## PRODUCT/ PROCESS CHANGE NOTICE

**Number:** 1602-1

**Reason for Change:** Packaging change to the circuit assembly.

**Products Affected:** 3225 TCXO C-series and D32G-series. (See below for full list of part numbers).

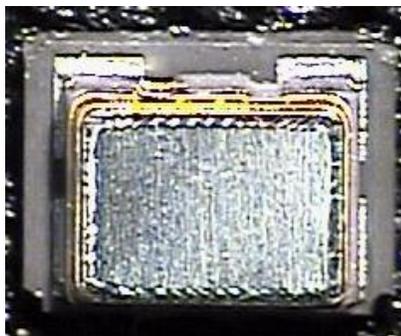
**Effect on Product Performance:** The original package configuration is a 3225 crystal ceramic package (contains crystal only) stacked on top of a 3225 ceramic substrate containing the compensation IC. This stack-up forms the complete TCXO.

The new package configuration is a crystal and compensation IC housed together in a 2520 ceramic package stacked on top of a 3225 ceramic "carrier" substrate.

The bottom footprint, pin configuration, and overall dimensions remain the same.

## Original

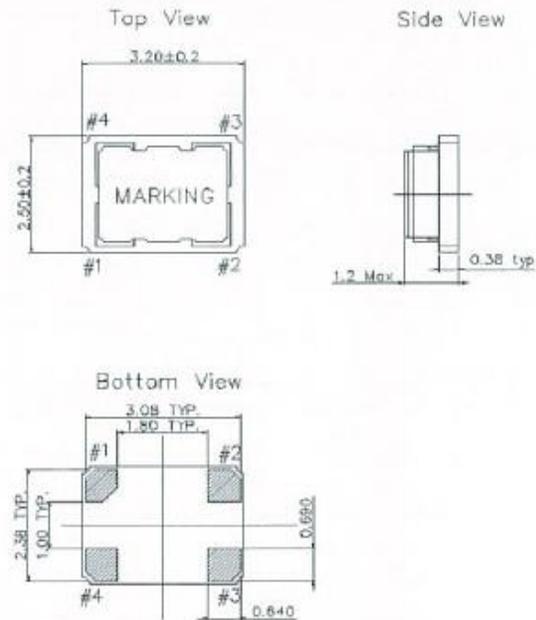
This modification will result in on-going component availability and enhanced manufacturability with no change in component electrical performance.
